NOTICE OF ERROR
REPLY

Water right number: 37-21221

W. Stanley Standaal
S. 17 T. 6S R. 13E

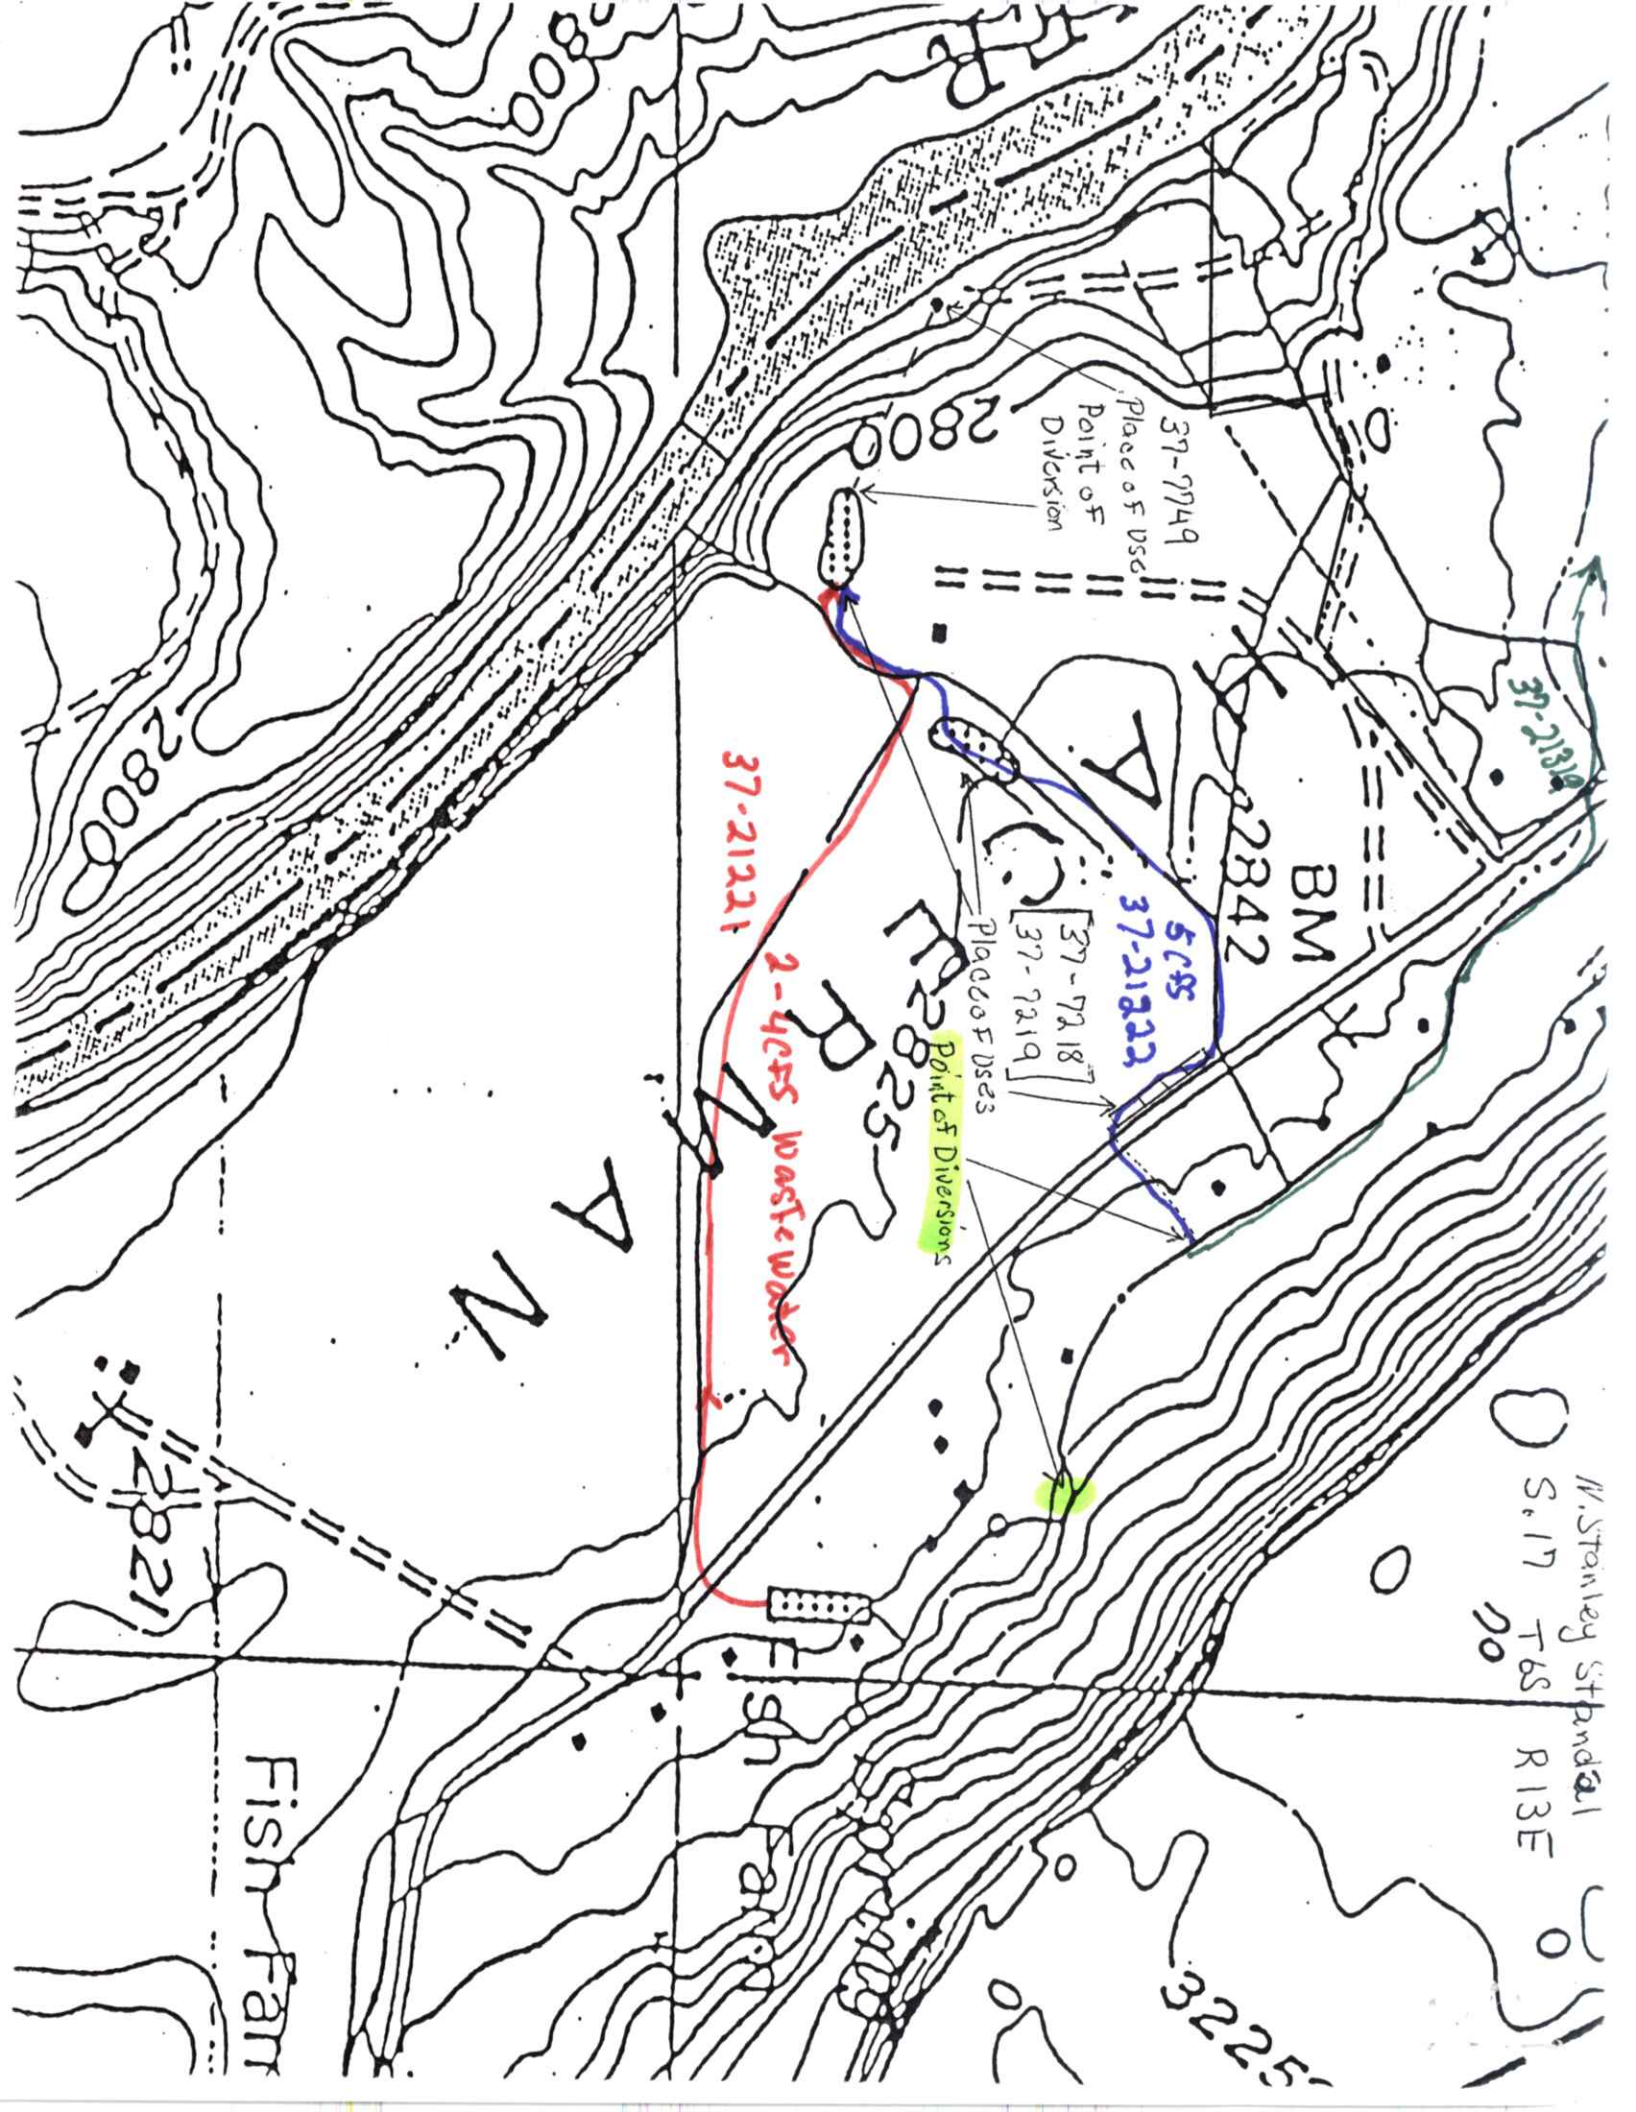
How this right is used in combination with Right # 37-21222.

This Right should be added to Right # 37-21222 as additional water for The Fish Prop. Facility in S. 17, Lot 3 SE SW. Water Flow ^{Road} through this facility ranges from 7 to 9 CFS. Right # 37-7749 Diverts at the outflow of the Facility.

Rights # 37-21221 and 37-21222 Total Flow should not be limited to 4.26 CFS.
